DESIGN/DEVELOPMENT REVIEW COMMISSION
DESIGN REVIEW DISTRICT
HISTORIC AGENDA
EVALUATION SHEET
Case # 11

ADDRESS: 1420 Hagood Avenue

REVIEW DISTRICT: Melrose Heights/Oak Lawn Architectural Conservation District

NATURE OF REQUEST: Request Certificate of Design Approval for new construction

Red outline of carport is shown

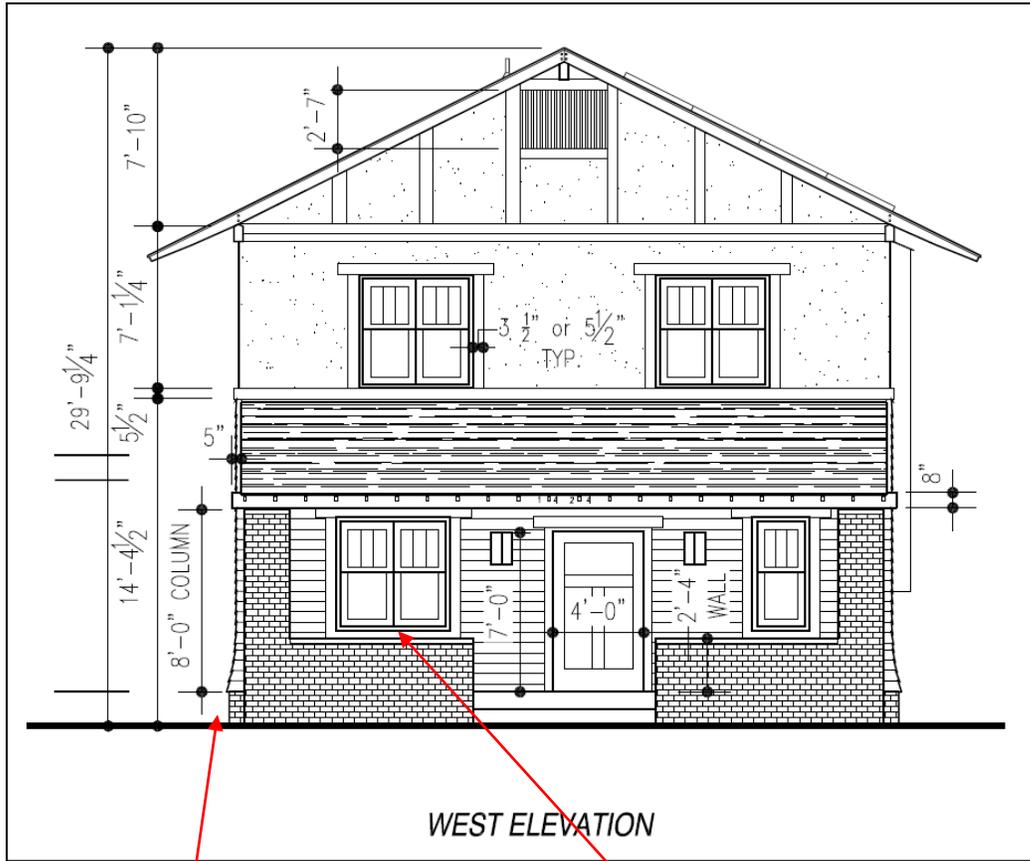
The proposal is for a pre-fabricated metal carport, big enough for two cars. This is proposed to be placed behind the house, to minimize visibility, but it would appear that it will be visible along the right side of the house as it will extend past that side several feet. Its visibility is uncertain from the left side, but an abandoned road bed along that side suggests that there is likely some visibility there as well. This proposed carport has a flat roof and thin metal posts, therefore it is not compatible with the house in terms of roof shape.

-That the carport is excluded from approval and that it be deferred to staff so that staff can determine visibility from the public right of way and make a decision for approval

Proposed House (see attached plans for larger detail)

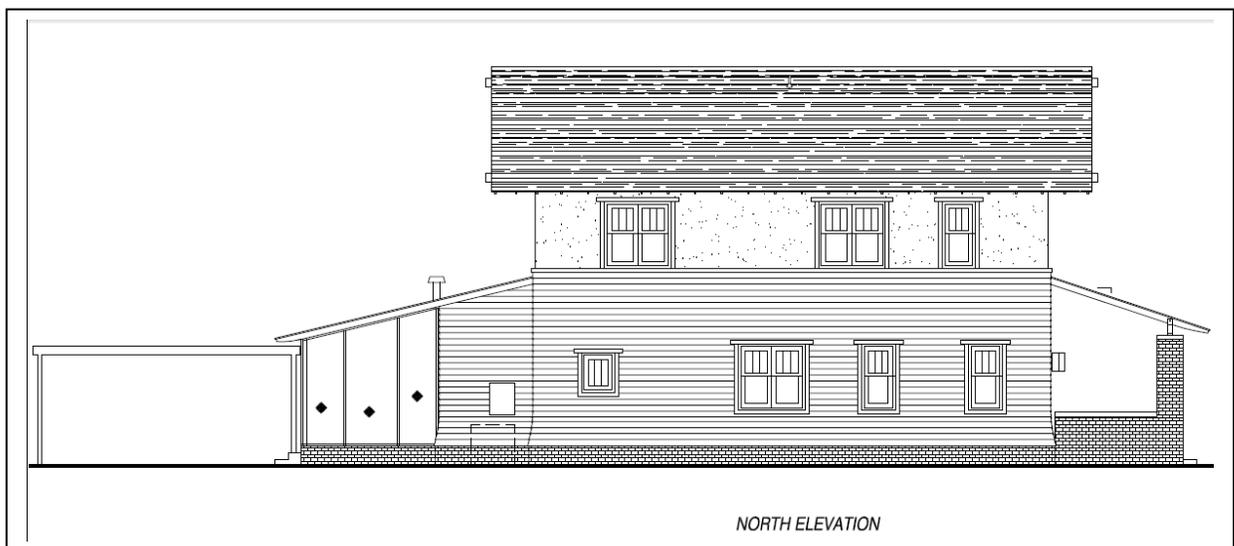
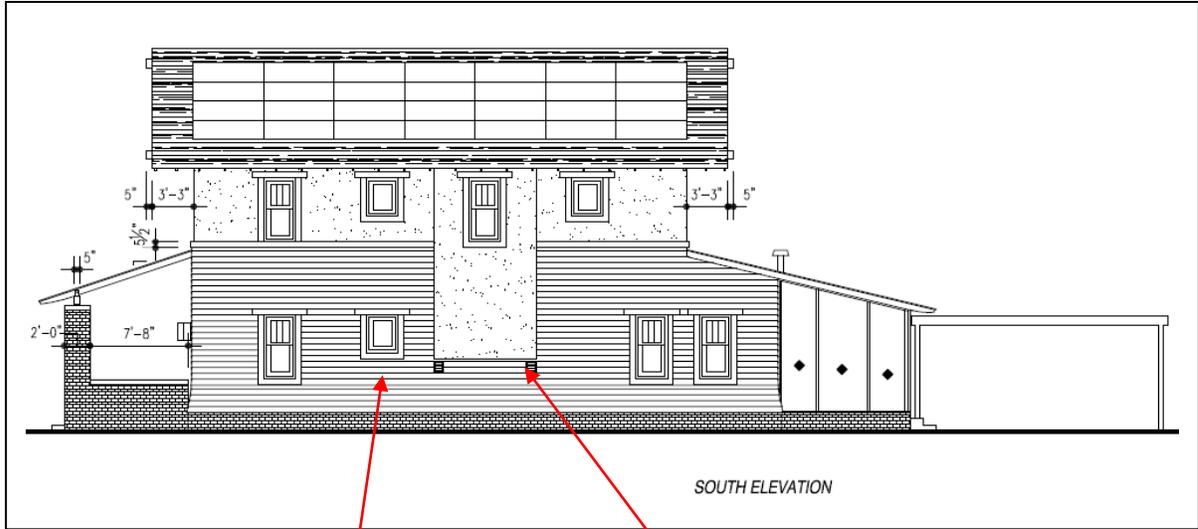
Curve at base of wall is not consistent with area; paired windows should have a muntin; the proposed front door is overly wide

Small windows are too numerous

Projecting bay on south elevation is unlike anything found on the block or street.

- That the proposed vinyl windows either be replaced with a window consistent with the guidelines or that they be concealed entirely by an exterior window that meets the guidelines, as determined by staff
- That the paired windows gain a mullion between them
- That at least one of the small windows is either removed or enlarged to a full size on the south wall
- That the gable's faux half timbering be removed
- That any new gable vent detail must be reviewed by staff
- That the projecting bay be removed
- That the front door be narrowed to a width similar to historic doors
- That the curve at the base of the walls be removed
- That the foundation retain a brick appearance but be minimized in depth in order to allow the siding or a skirt board to overlap the foundation in a way that is consistent with historic buildings
- That all details be deferred to staff

SOUTH ELEVATION

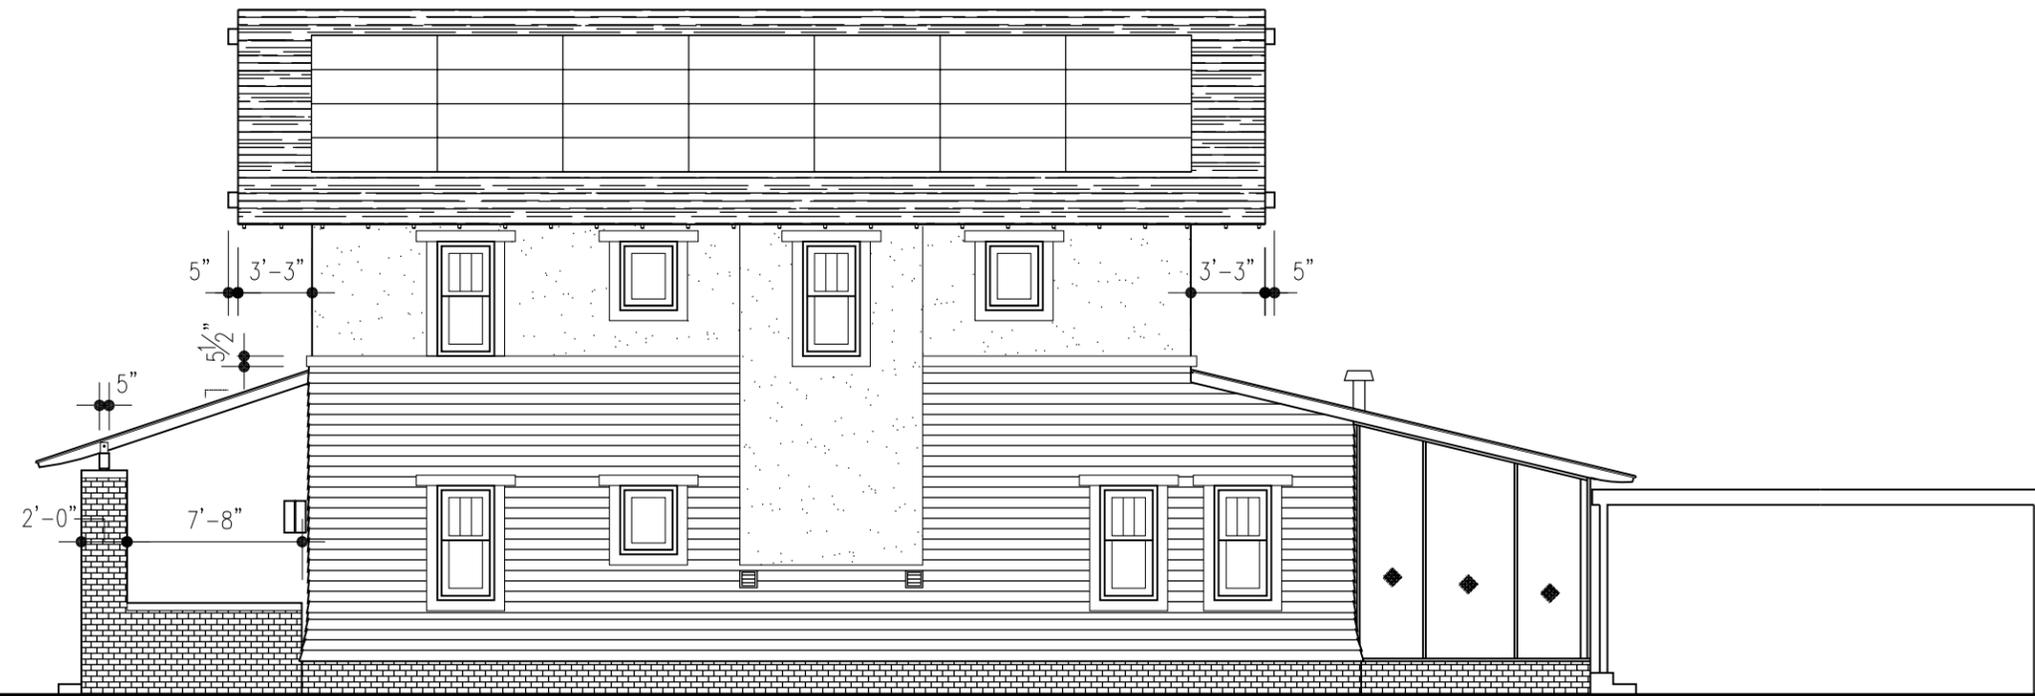
Generally the massing is compatible with existing historic buildings, however the large projecting, two-story bay on the south side is unlike any massing detail found on the block or street.

The rhythm of openings is generally visually compatible with historic buildings. The relationship of solids to voids does not seem consistent on the south side in the second bay due to the undersized, square windows used on both floors. At least one of these should probably be enlarged to create a ratio of height to width in the bay that is more visually compatible with historic buildings.

Projecting Bay: The south wall features a projecting 2-story bay that is approximately a foot deep and a single bay wide. This is not a feature found on the block or street, and therefore does not

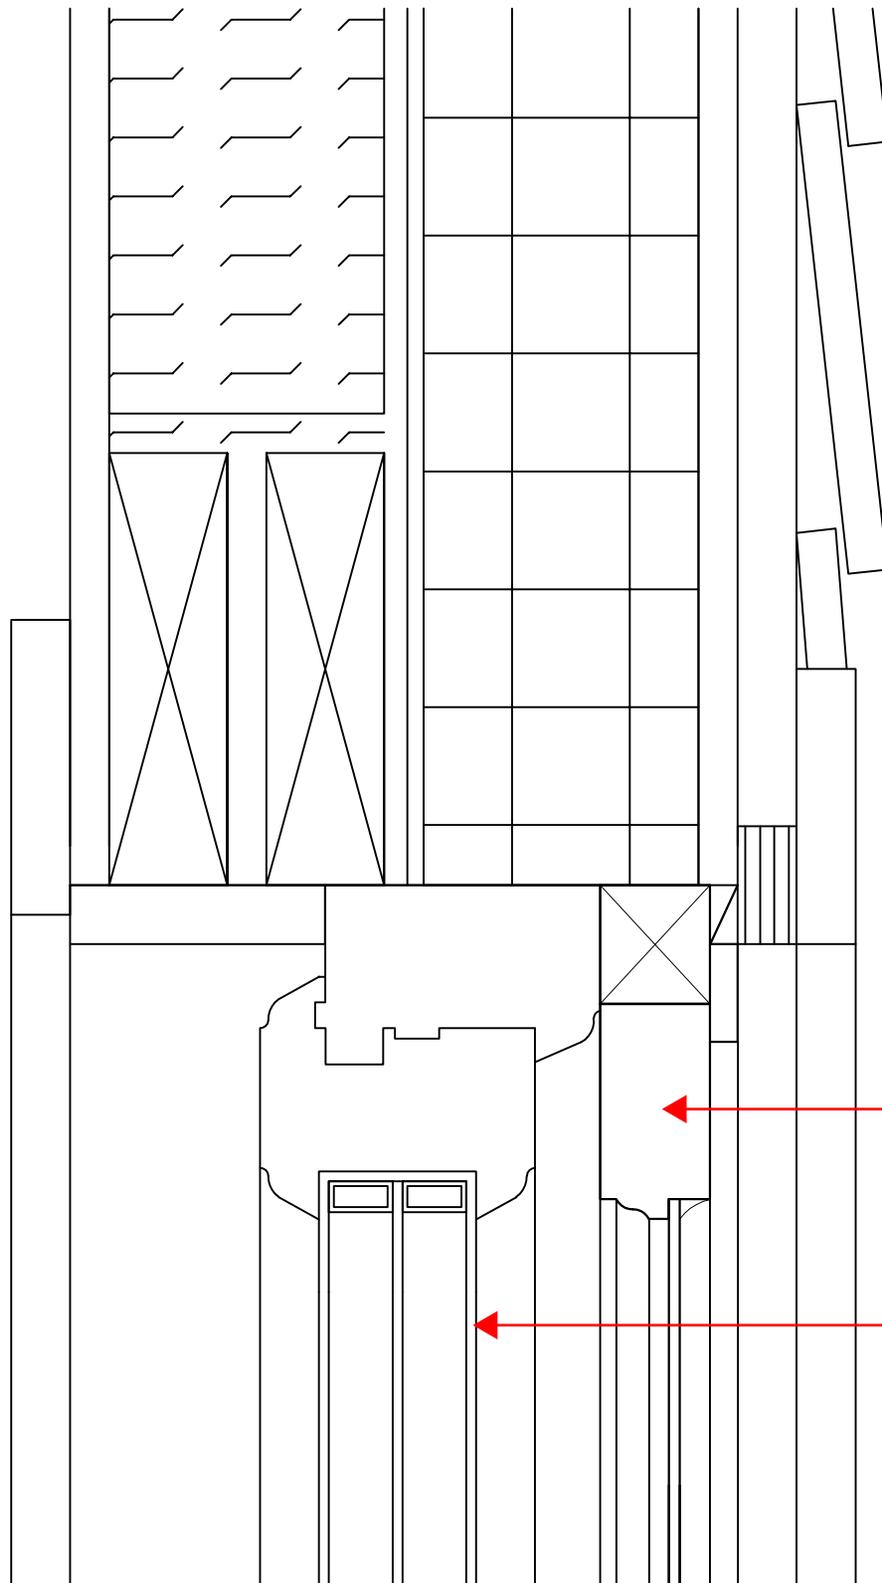
The applicant has provided drawings of this arrangement as well as photographs of the proposed window. On the drawing it is clear that there will be a gap between the top sash and the casement; this gap is proposed to be filled in with a wood block directly behind the meeting rail, scribed to the profile of the vinyl window along its stiles. This will make the top sash about twice as thick as a historic wood sash and the PVC bottom sash will appear further inset than on a historic sash. In the drawings submitted the top sash appears to be shorter than the remaining space, suggesting that it does not extend to about halfway down the opening as historic windows do. These details would not be consistent with the scale, profile and relief of details on historic buildings.
